CITY OF NOVI CITY COUNCIL
JULY 28, 2025

SUBJECT: Final approval of Feldman Kia, JZ24-32, with Zoning Map Amendment 18.746 to rezone from Non-Center Commercial to General Business with a Planned Rezoning Overlay Agreement.

PLAN REVIEW CENTER REPORT

Rezoning Request from NCC (Non-Center Commercial District) to B-3 (General Business) with Planned Rezoning Overlay (PRO)

L-3

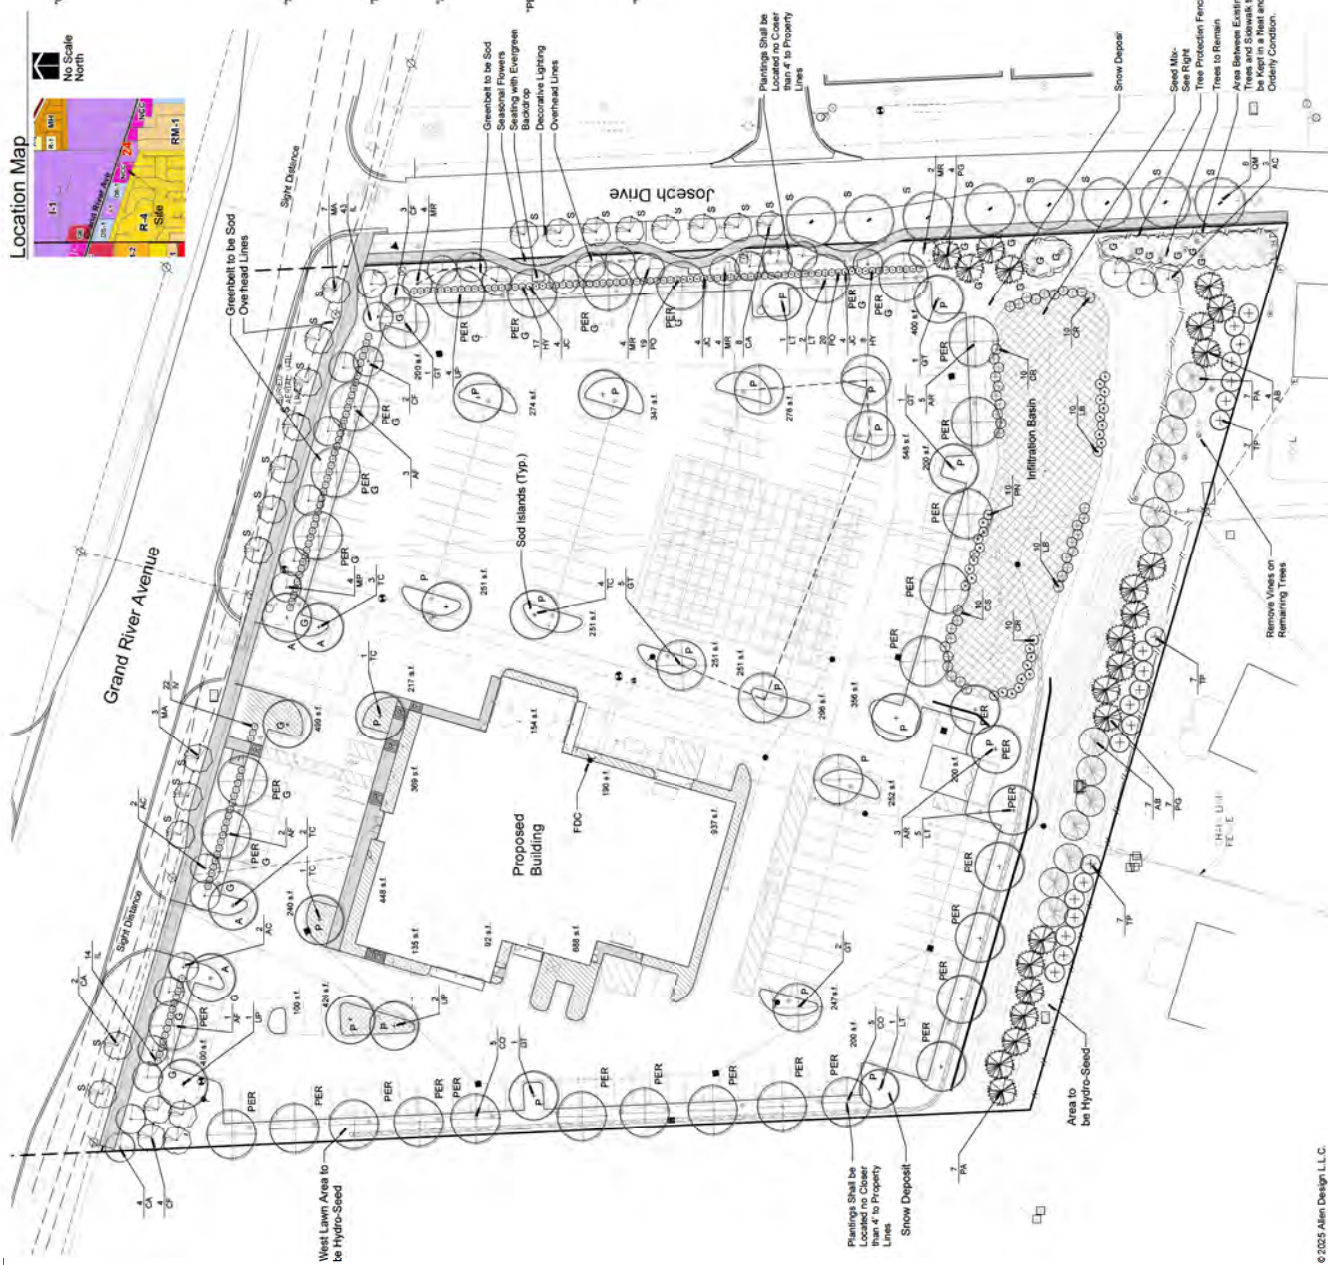
Item	Required	Proposed	Meets Code	Comments
				<u>from the landscape plan and note that on the utility plan.</u> 2. There are a number of tree/light pole conflicts or sites where they are very close. <u>Please adjust the lighting and/or tree locations.</u>
Proposed grading. 2' contour minimum (LDM 10)	Provide proposed contours at 2' interval	<ul style="list-style-type: none"> • Sheet 4 • The southern berm is being increased in height to between 7-10 feet 	Yes	
Snow deposit (LDM 10)	Show snow deposit areas on plan	Two are shown	Yes	<u>Please add more to the plan so all of the site's snow can be handled and move the southeast pointer to a gap north of the pond where it is more likely to be used.</u>
LANDSCAPING REQUIREMENTS				
Parking Area Landscape Requirements (Zoning Sec 5.5.3.C and LDM 5)				
General requirements (LDM 5)	<ul style="list-style-type: none"> • Clear sight distance within parking islands • No evergreen trees 	No proposed plantings appear to block visibility within the parking lot	Yes

Item	Required	Proposed	Meets Code	Comments
				3. <u>If berries are desired in future years, some male winterberries should be mixed in at a rate of 1 male per 8-10 females.</u>
Type and amount of lawn		Sod is indicated everywhere but in the infiltration basin area	Yes	
Cost estimate (LDM 10)	For all new plantings, mulch and sod as listed on the plan	Yes		
Planting Details/Info (LDM Part III) – Utilize City of Novi Standard Details				
Canopy Deciduous Tree	Refer to LDM for detail drawings	Yes – Sheet L-3	Yes	
Evergreen Tree		Yes – Sheet L-3	Yes	
Multi-stem Tree		Yes – Sheet L-3	Yes	
Shrub		Yes – Sheet L-3	Yes	
Perennial/ Ground Cover		Yes – Sheet L-3	Yes	
Tree stakes and guys. (Wood stakes, fabric guys)		Yes – Sheet L-3	Yes	
Tree protection fencing	Located at Critical Root Zone (1' outside of dripline)	Yes – Sheet L-2	Yes	
Other Plant Material Requirements (LDM 11)				
General Conditions	Plant materials shall not be planted within 4 ft. of property line	Yes

ARCHITECTURAL SITE PLAN - SIGNAGE
1/2" = 1'-0"

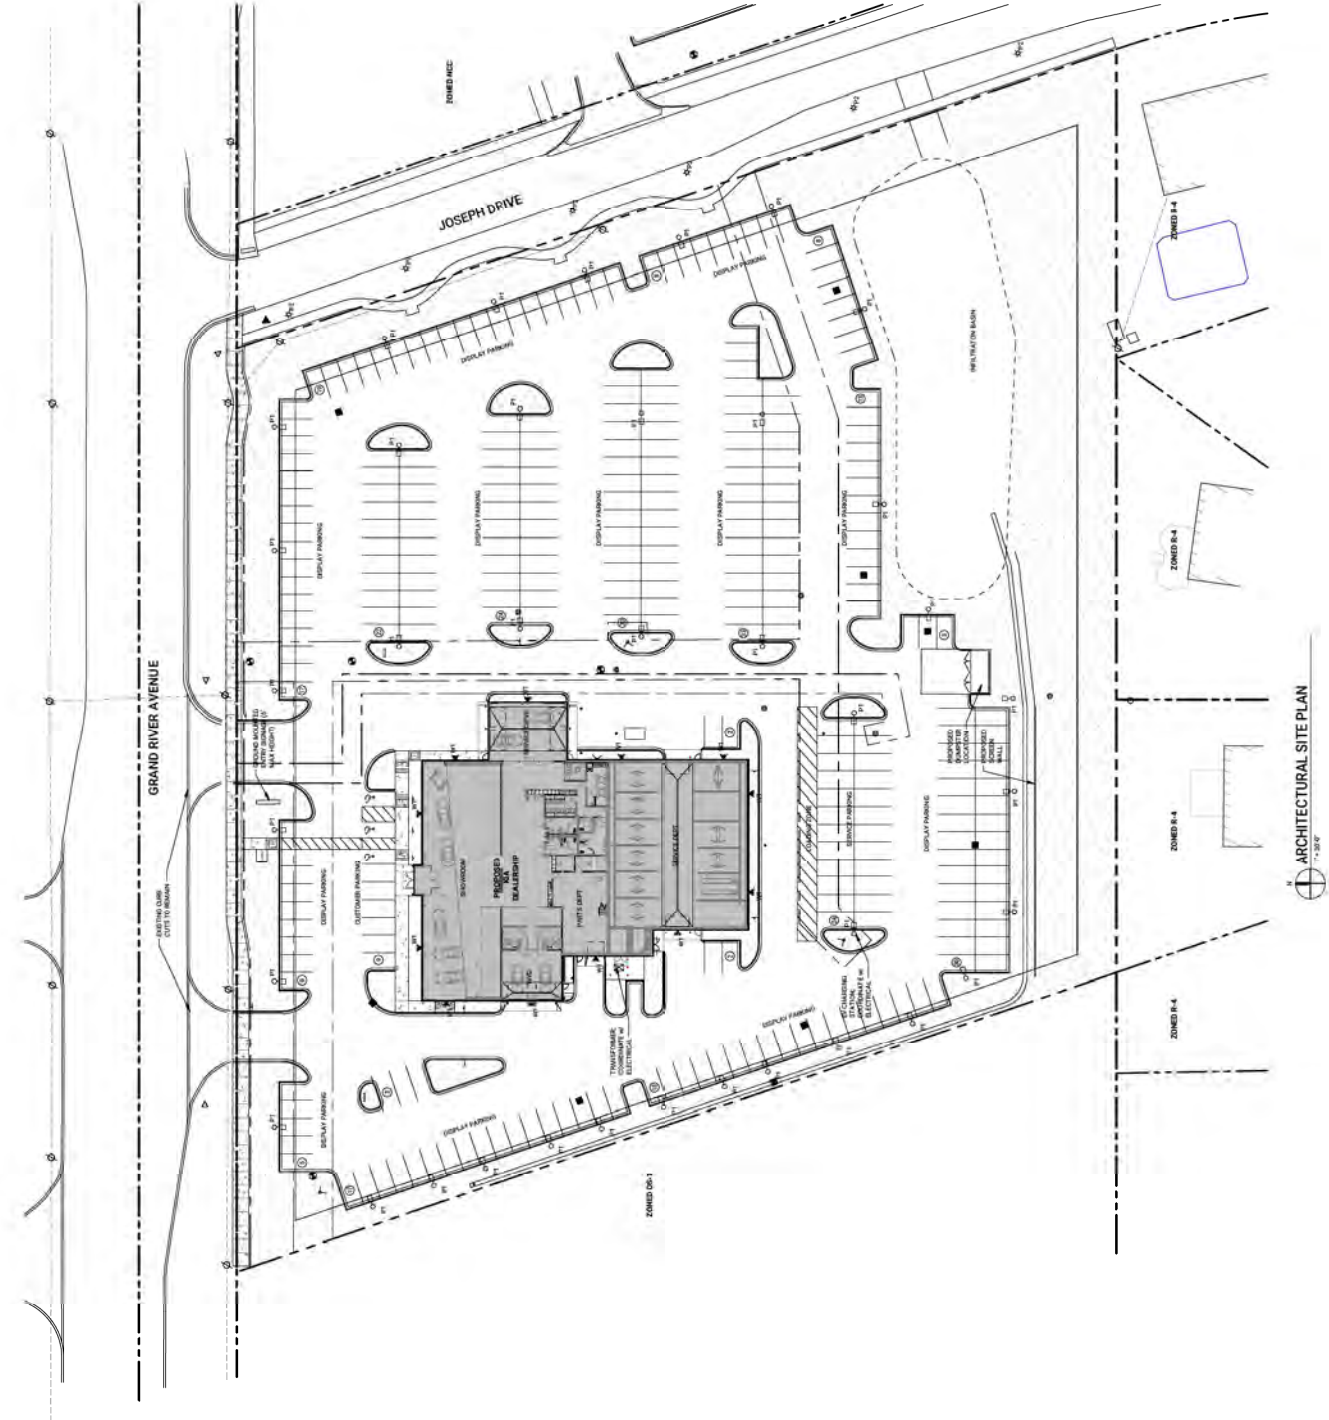
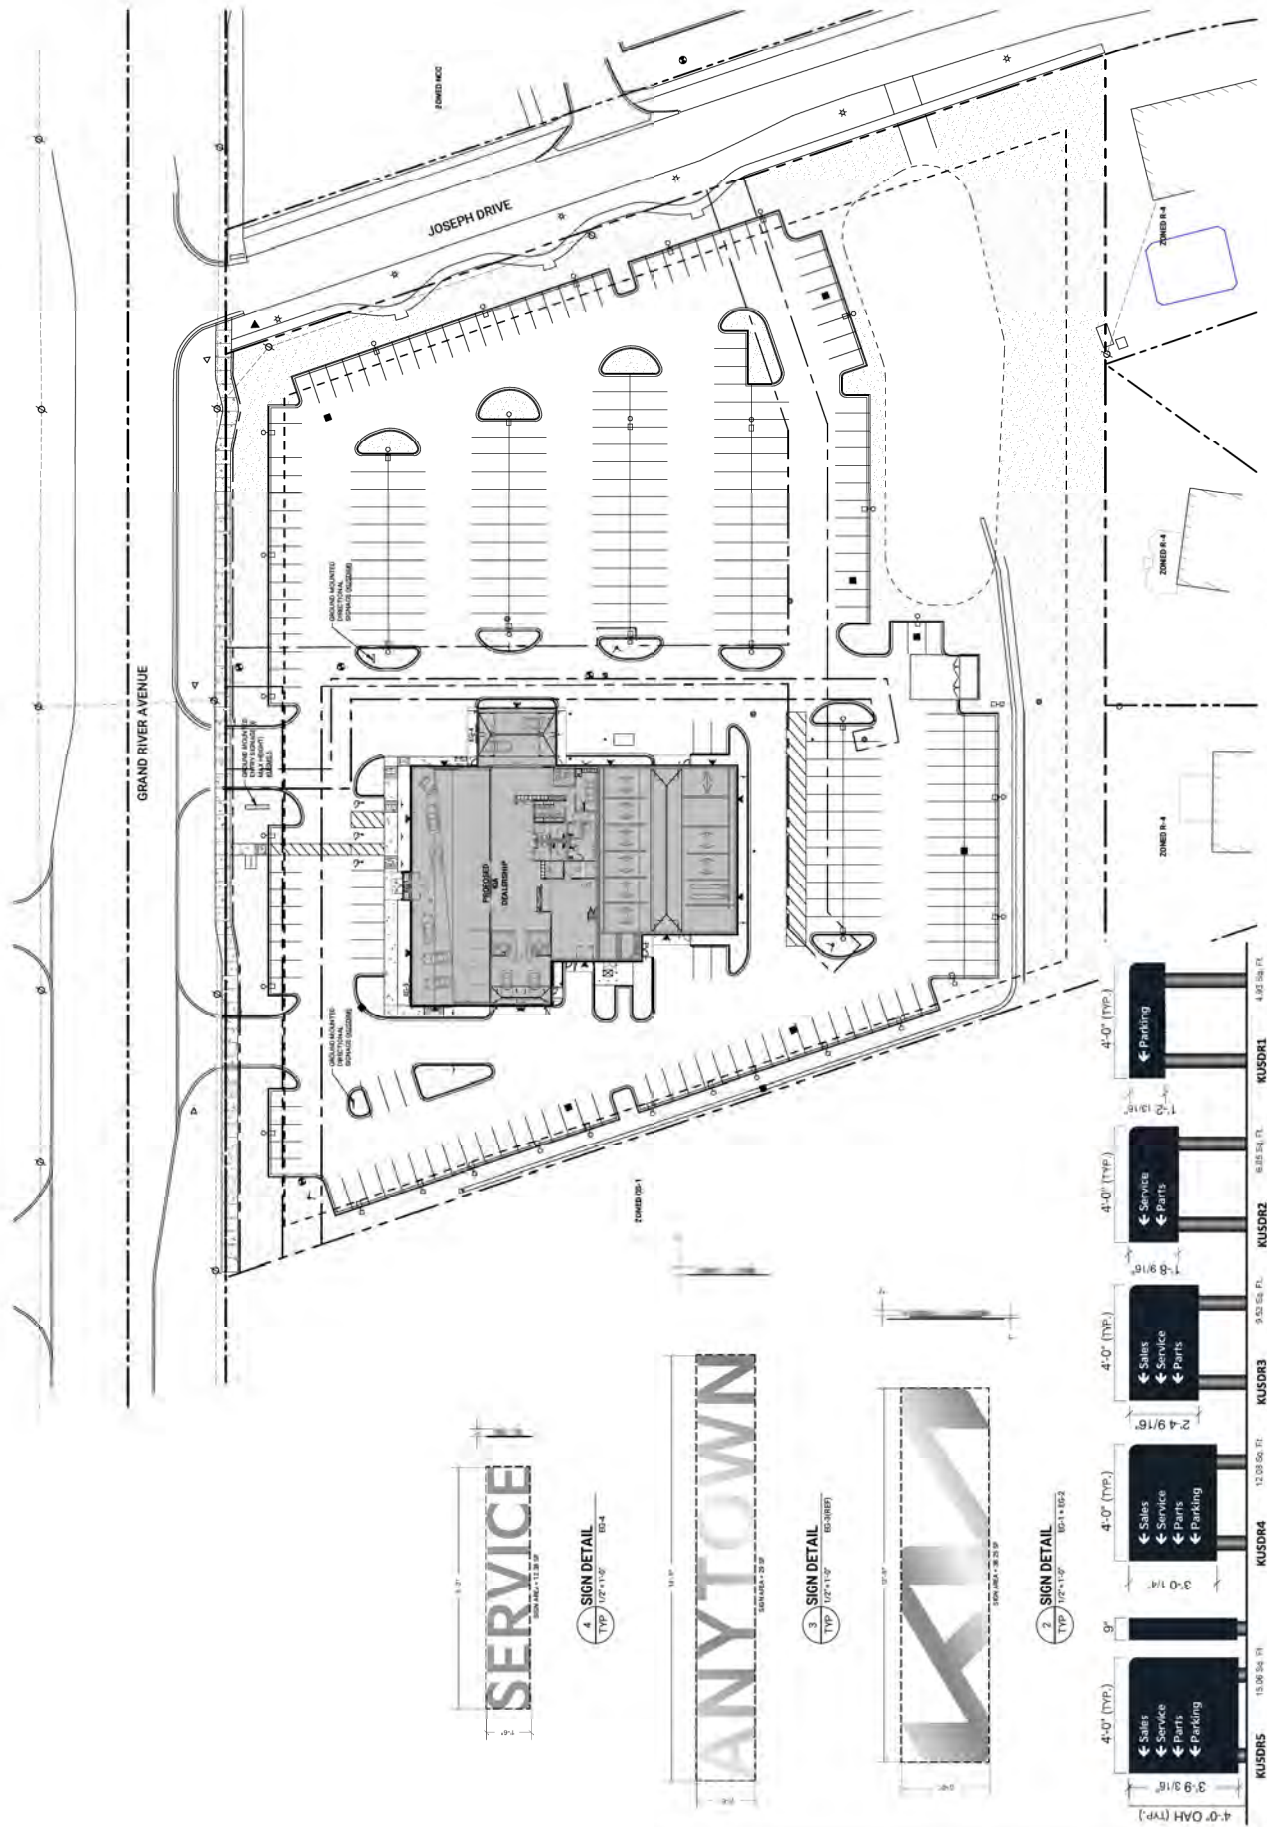
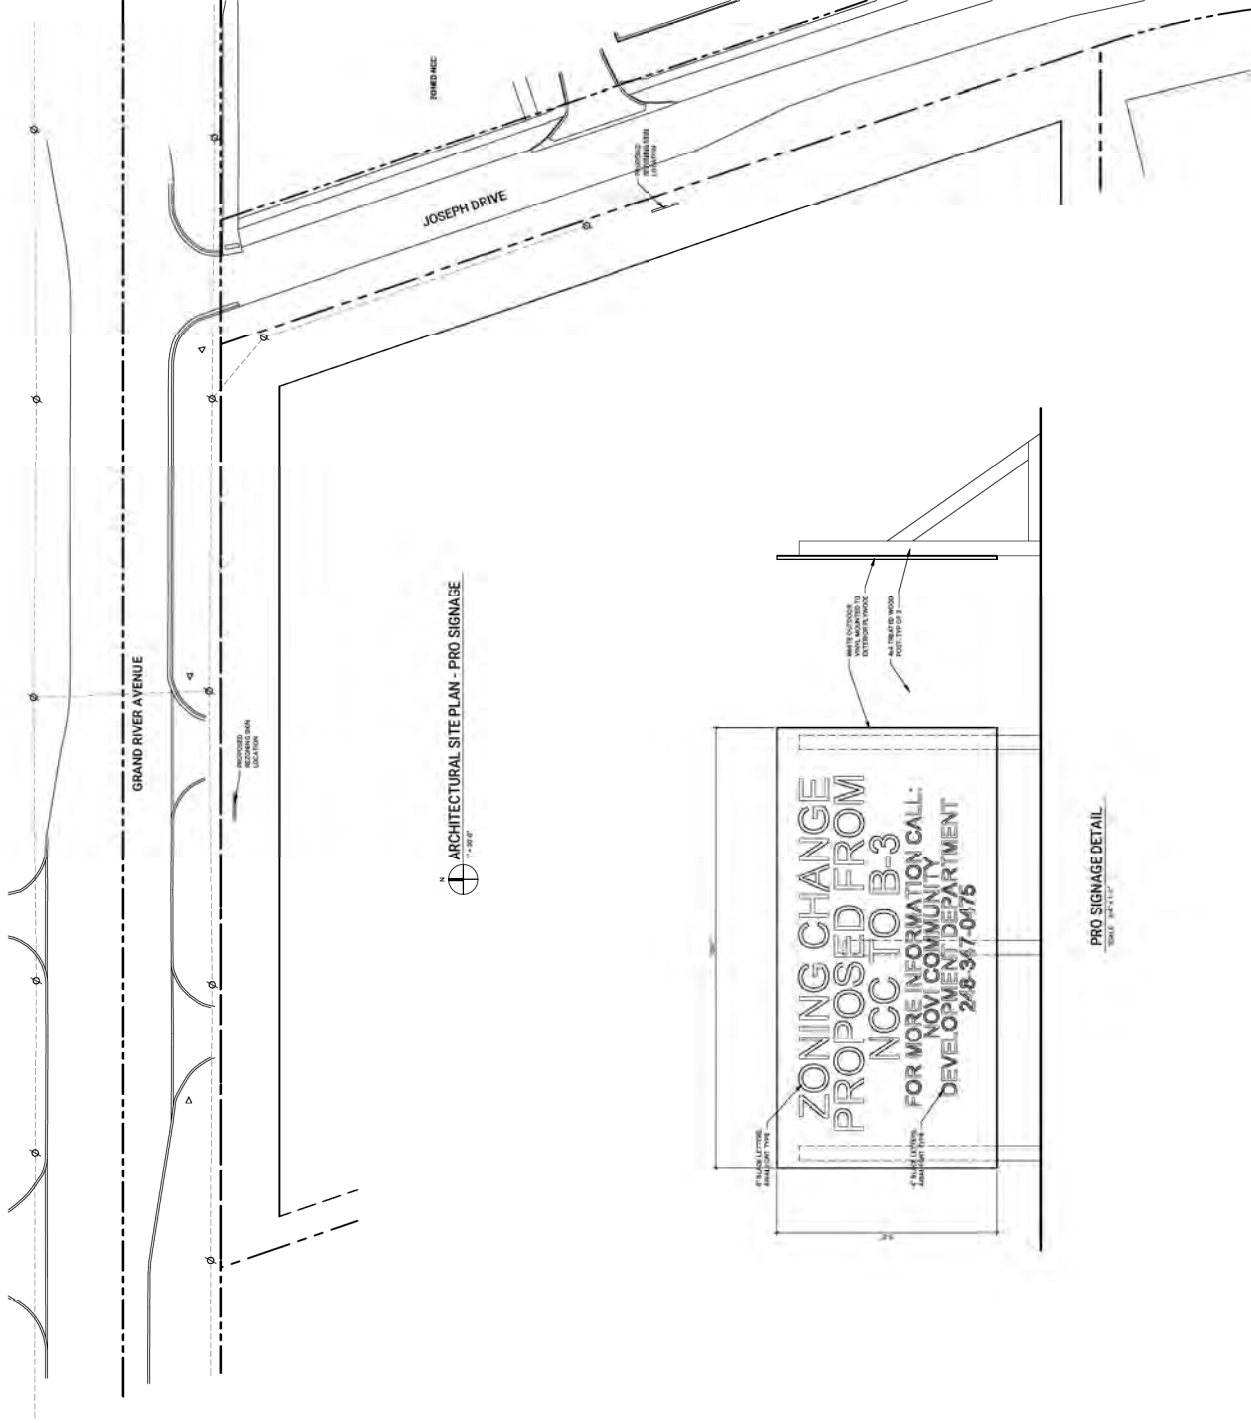
5. Signage: Proposed signage has been included in the PRO Concept plan submittal, and the applicant requests a deviation to allow the signage as proposed. In some cases, deviations from the Sign Ordinance (Chapter 28 of the City Code) have been included in previous PRO Agreements. The sign details provided in the submittal do not include all measurements in order to determine the total area of the signs. The sign ordinance allows the following in the B-3 district for a single tenant building or development parcel: 250 square foot maximum – 1 wall sign (shall not exceed 1 sf for each 2 feet of setback from the nearest thoroughfare; and (1) ground sign
